CITY OF CODY
PLANNING, ZONING AND ADJUSTMENT BOARD
TUESDAY, MARCH 23, 2021
CITY HALL COUNCIL CHAMBERS @ 12:00 NOON

**CITY OF CODY
PLANNING, ZONING AND ADJUSTMENT BOARD
STAFF REPORT**

MEETING DATE:	MARCH 23, 2021	TYPE OF ACTION NEEDED	
AGENDA ITEM:		P&Z BOARD APPROVAL:	
SUBJECT:	PRELIMINARY PLAT OF THE MOUNTAIN VIEW MAJOR SUBDIVISION— A 15-LOT SUBDIVISION. SUB 2021-03	RECOMMENDATION TO COUNCIL:	X
PREPARED BY:	TODD STOWELL, CITY PLANNER	DISCUSSION ONLY:

MEETING DATE:	MARCH 23, 2021	TYPE OF ACTION NEEDED	
AGENDA ITEM:		P&Z BOARD APPROVAL:	
SUBJECT:	FINAL PLAT AND CONSTRUCTION PLANS FOR THE SHADOW MOUNTAIN SUBDIVISION No. 2— A 32-LOT SUBDIVISION. SUB 2020-03	RECOMMENDATION TO COUNCIL:	X
PREPARED BY:	TODD STOWELL, CITY PLANNER	DISCUSSION ONLY:

Preliminary Plat
Preliminary utility plan
Preliminary landscape/drainage plan

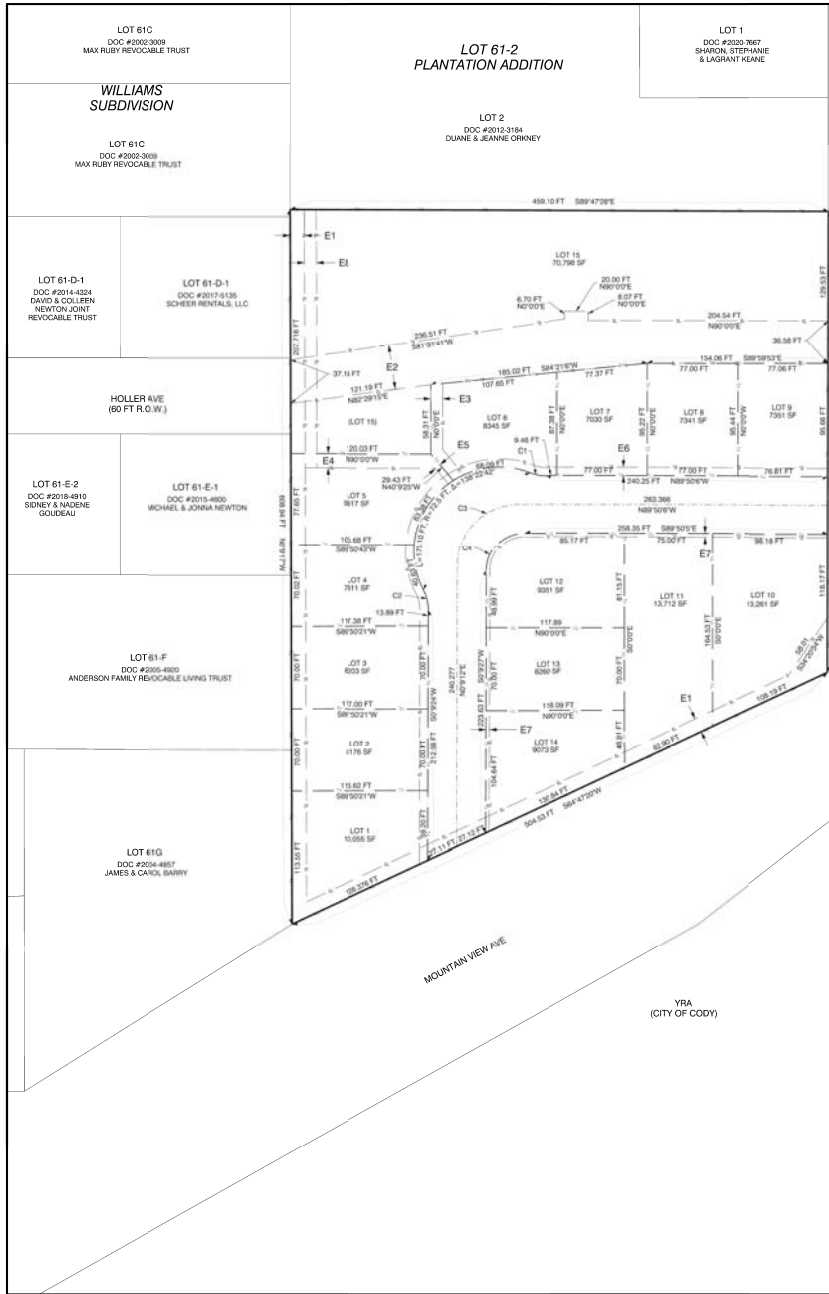
Comment: To meet this requirement, a storm water pipe will be needed to carry storm water from the southeast curb line to the proposed infiltration trench, as opposed to a valley gutter. The drainage concept plan is not clear which method is proposed.

Comment: A conceptual drainage plan is shown on the Utility Plan sheet. It involves carrying the street drainage to an infiltration trench on the north side of Lot 5, and capturing the drainage from Lot 15 in a swale in the northwest corner of the subdivision. More detailed drainage plans, including elevations/contours and

Skyview. Any mailbox located along 29th or Mountain View Drive, will need a gravel pullout as well. Final location must be authorized by both the Post Office and City. Provide a mailbox easement if needed.

3. The street name of "Skyview Drive" was not approved by the street name committee (too similar to Skyline Drive). Please provide three alternative names for committee consideration. Personally, "Skyview Loop" would seem to work. (While discussing street names, the Fire Marshal Recommends naming the driveway on Lot 15. Please provide three alternatives. (Marlisa Lane or Marlisa Loop may be acceptable.)

5. Include lot and street survey monumentation on the final plat.
6. Verify easement widths are acceptable to all applicable utility providers. It is expected that easement E7 will likely need to be 5 feet and E3 20 feet.

9. Clarify the street section detail (51' right-of-way).
10. Since the plans for Lot 15 are not set up to allow for future subdivision (inadequate access street, power layout, etc.), individual sewer services are not required to be provided to each individual unit. Units within the same building could share sewer.

12. Provide rounded approach returns on the connections to 29th Street and Mountain View Drive.
13. Include a private street sign, stop sign, and "No Outlet" for the driveway on Lot 15.

6. On the interior street, coordinate the curb design with Public Works (3" tall mountable design is authorized), and add a radius to the south end of the interior street so that it meets Mountain View Drive closer to perpendicular.

7. For purposes of verifying the adequacy of the street base, use in building construction, and stormwater design, provide a geotechnical report.
8. Provide an engineer's stormwater report and drainage plan for the subdivision. Address the recommendations in section "T" of this report in the storm water plan and design.

9. A maintenance agreement and/or homeowner's association shall be established for maintenance of the storm water infiltration facilities (trench and swale). Submit the proposed documents with the final plat. Also include an explanatory note referencing such on the final plat.

PROJECT NUMBER 6343.001-040
SHEET NUMBER 23
DRAWING NUMBER RW-4

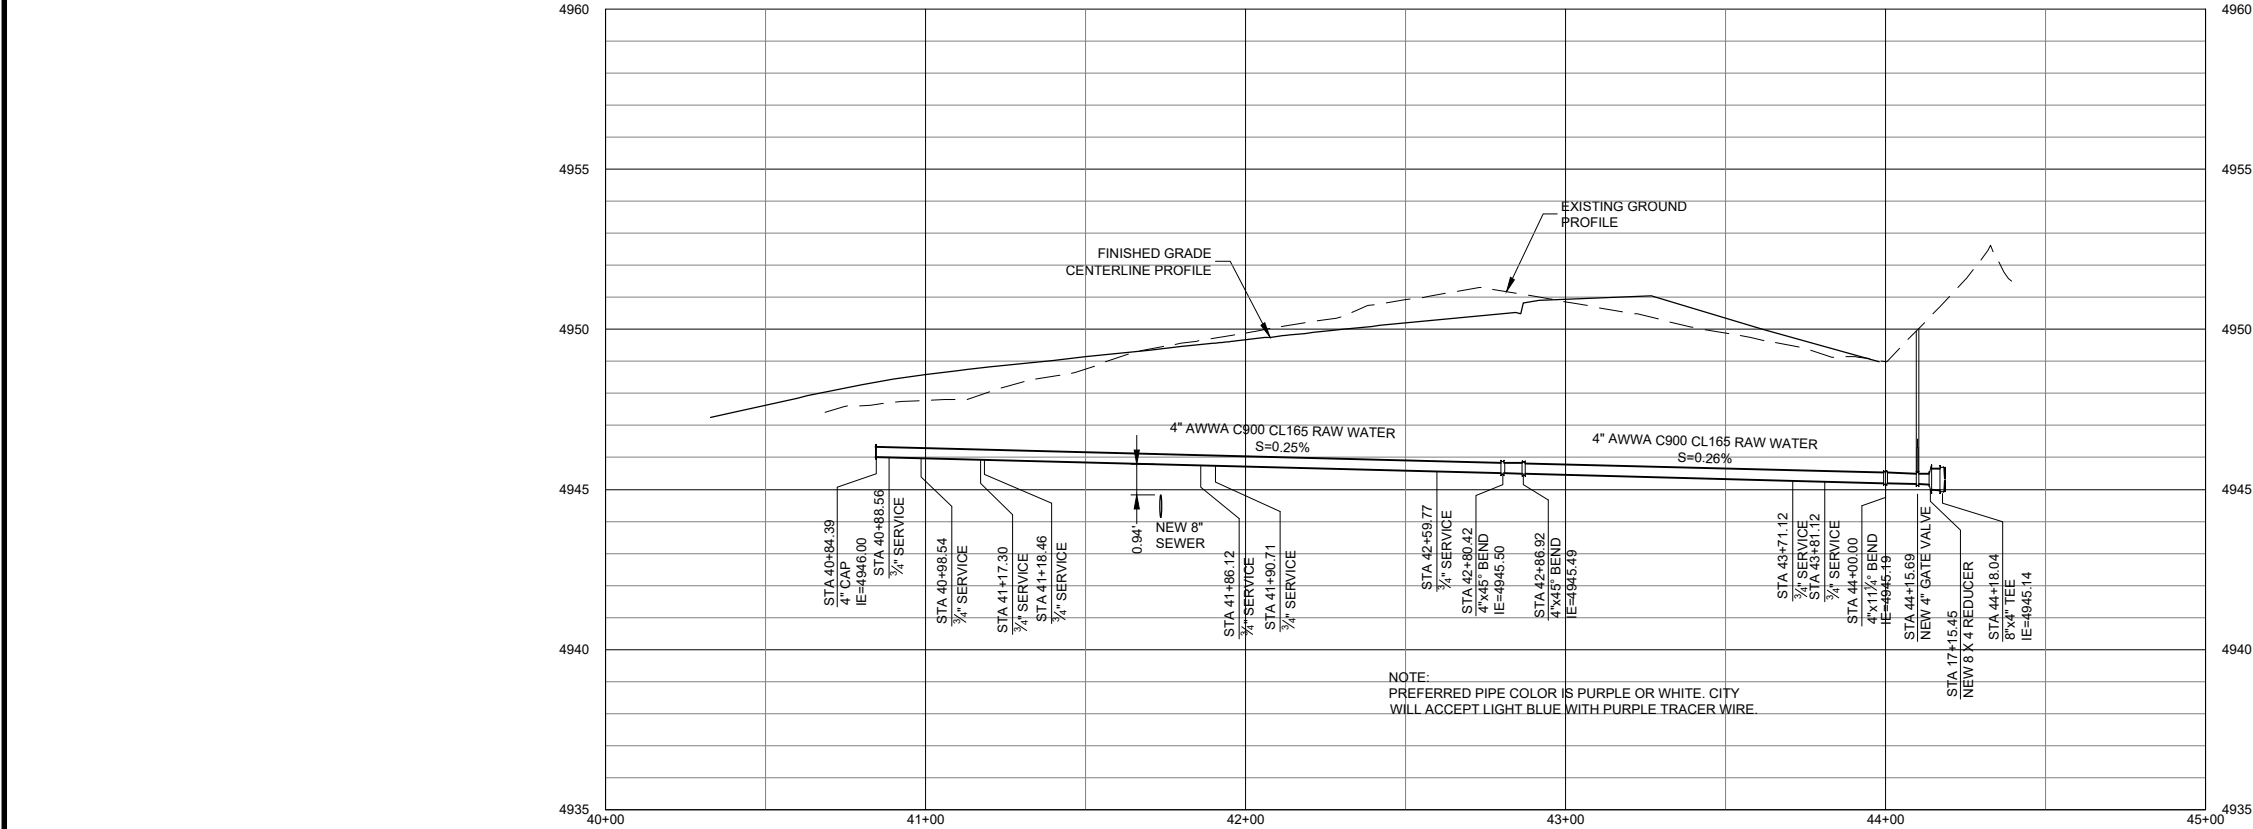
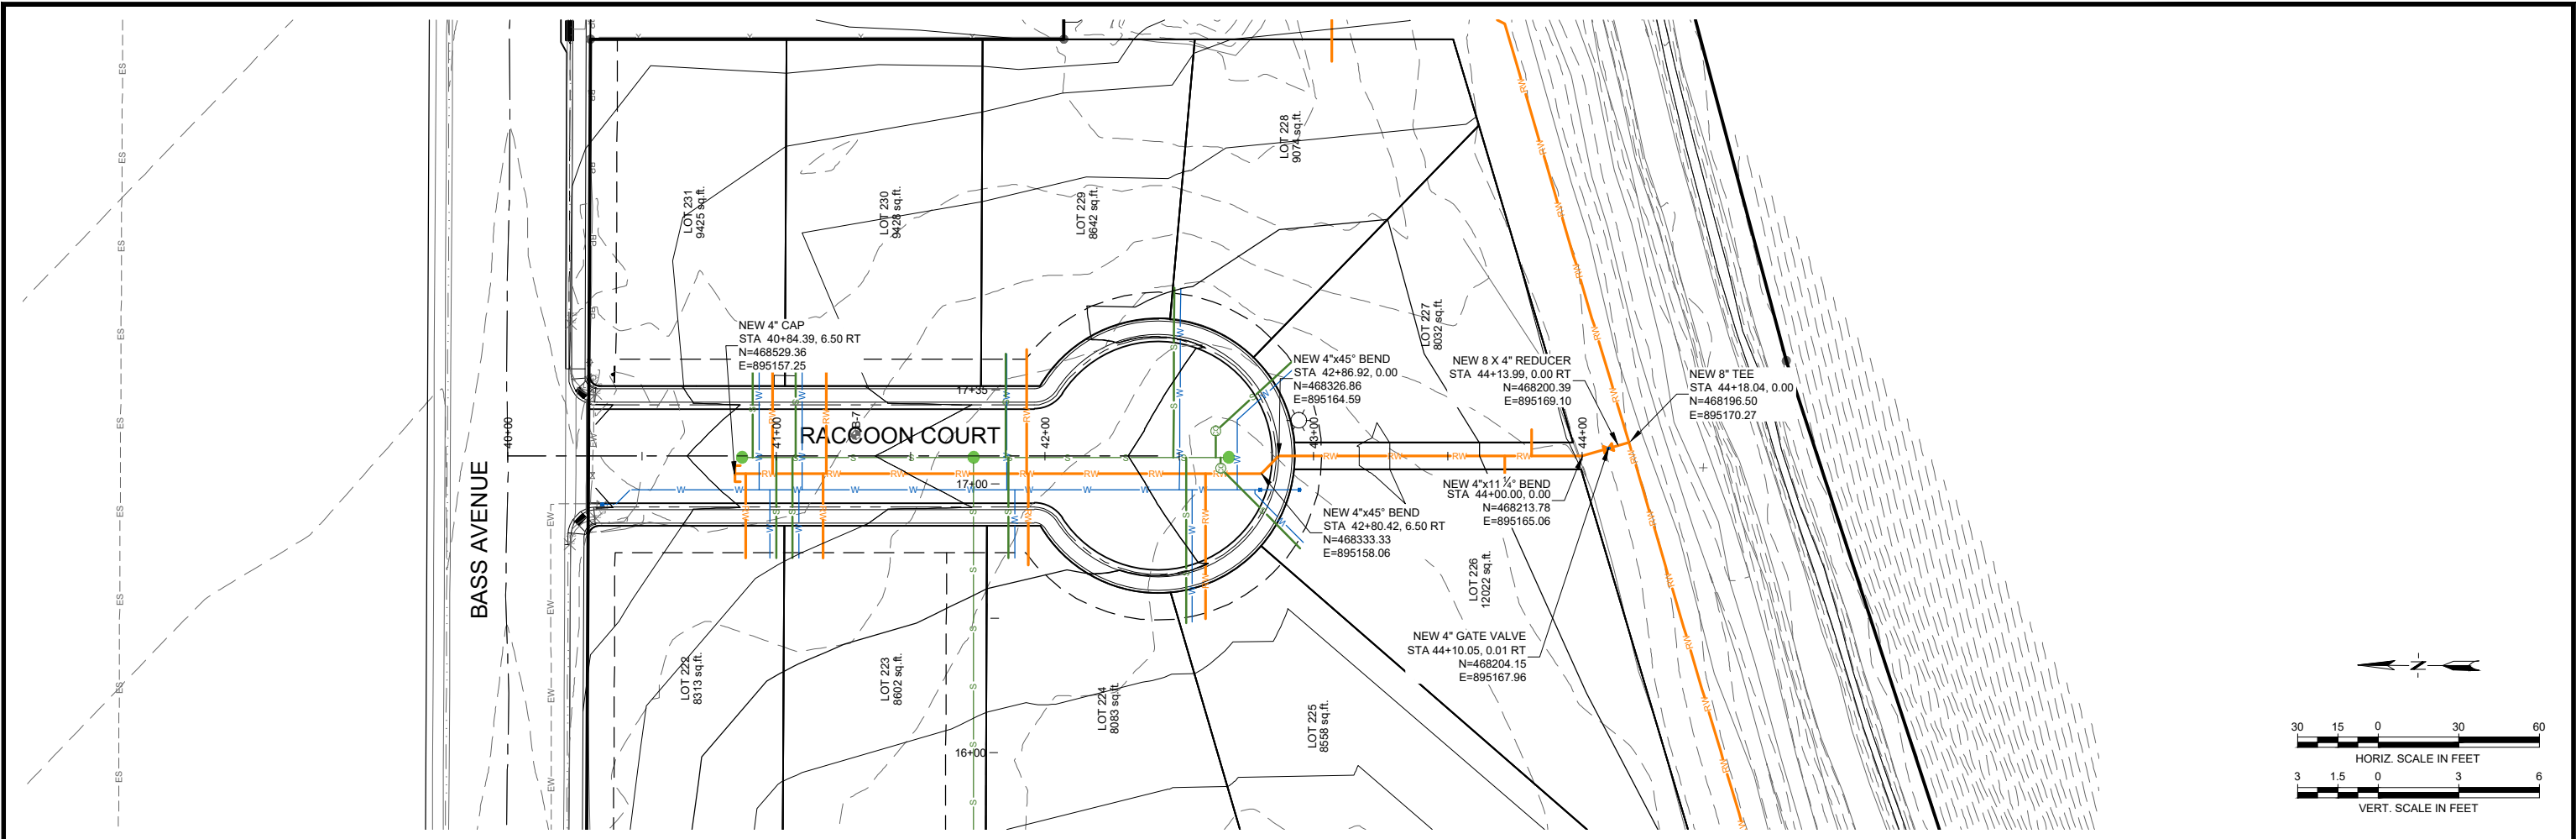
- iii) On Sheet RW-5, move the services for Lots 223 and 230 to the south, to provide more cover.
 - iv) On the side view of the "Typical Drivecut Detail" change "Slope 1:12 Maximum" to 1:48.

CODY	SHADOW MOUNTAIN SUBDIVISION NO. 2 COTTONWOOD VENTURES, LLC	WYOMING	PROJECT NUMBER 6343.001-040
			SHEET NUMBER 25
	STREET DETAILS 1

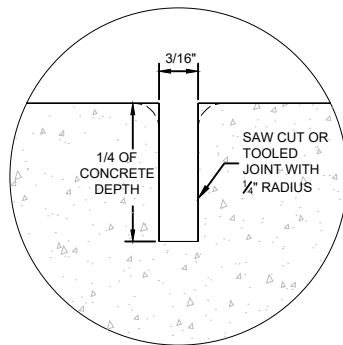
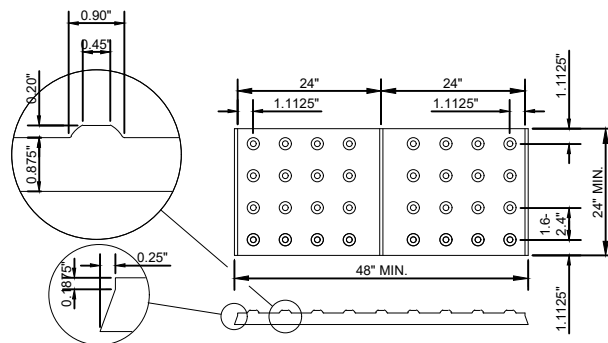
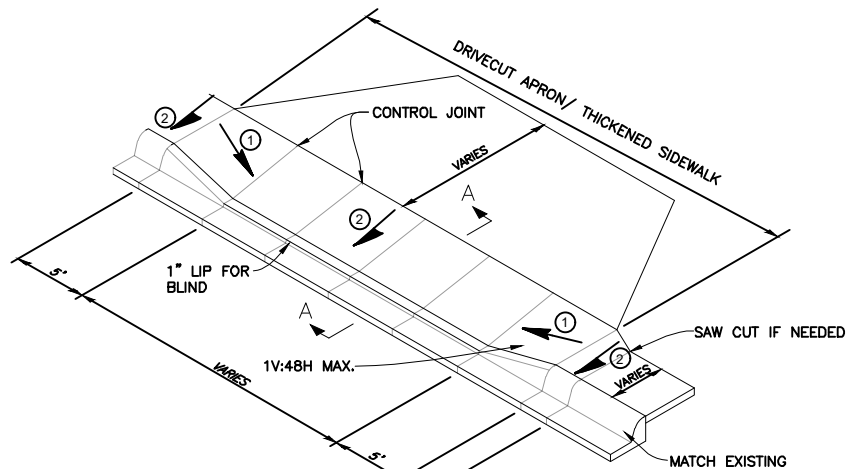
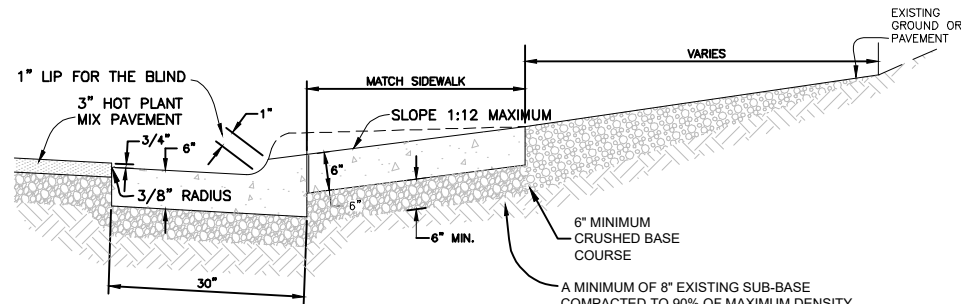
- b) Add the length and bearing of the western section of West Avenue to the plat.
- c) The curb details on Sheets G-3 and D-1 do not match. Coordinate curb detail with Public Works.

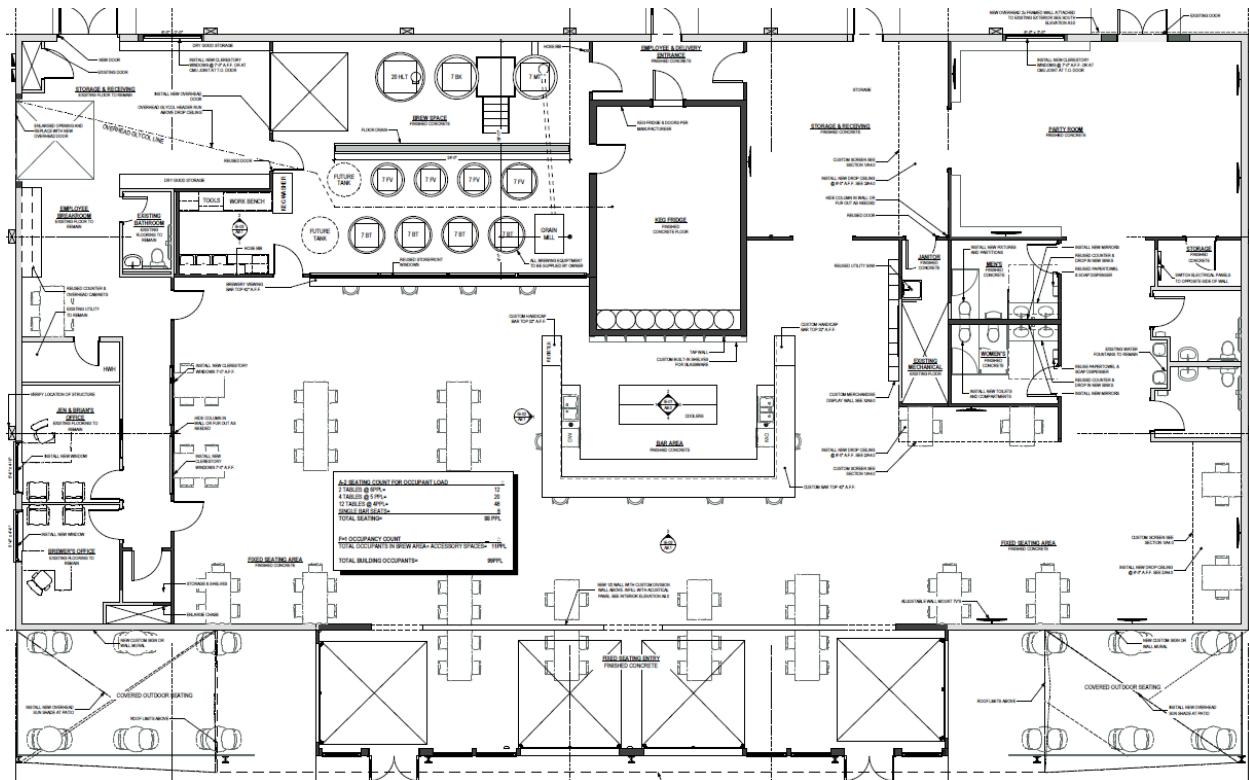
The applicant claims in their narrative an occupancy of 100 seats at the facility, and that by using the ratio of 0.3 spaces per fixed seat, only 30 parking spaces would be required by the ordinance. However, this ratio is only applicable to fixed seating, where tables and chairs do not move. It is also based on the assumption (although not noted in the code) that the maximum number of seats that the area can accommodate is being provided. The proposed seating of the facility is shown below. (Larger attached).
